# Issue List

### 05-29-23 CULVERS - GRAIN VALLEY, MO

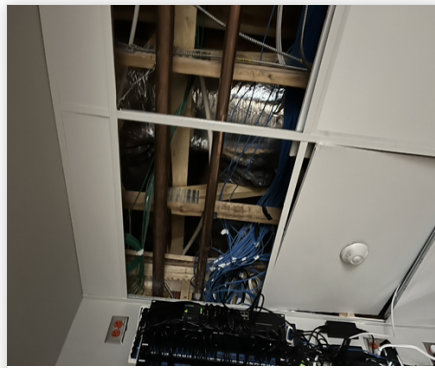
**Issue Name :** PRV3 cannot be raised up to look down grease duct  
**Description :** PRV3 hinge kit is installed on the same side as the conduit pipe which is preventing the unit from leaning back. Hinge kit needs to be installed on the opposite side of the grease spout. This will prevent duct cleaning and getting unit pressure.  
**Created By :** National TAB                      **Assigned To :** National TAB - Jacob Davidson  
**Status :** Open  
**Originated Date :** 05/22/2023 - Jacob Davidson - National TAB

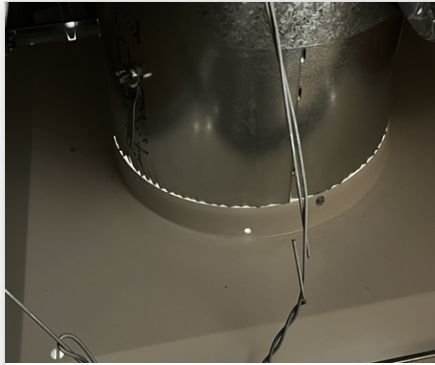
**Issue Name :** RTU2 diffuser 2-16 very low on flow, takeoff not accessible  
**Description :** Diffuser 2-16 on the GRD for the electrical room is very low on flow at 124 of 600 CFM. This value hasn't changed with moving air around which implies the damper is closed at takeoff, however tech is unable to reach takeoff to check for a damper due to ceiling restrictions.  
**Created By :** National TAB                      **Assigned To :** National TAB - Jacob Davidson  
**Status :** Open  
**Originated Date :** 05/23/2023 - Jacob Davidson - National TAB
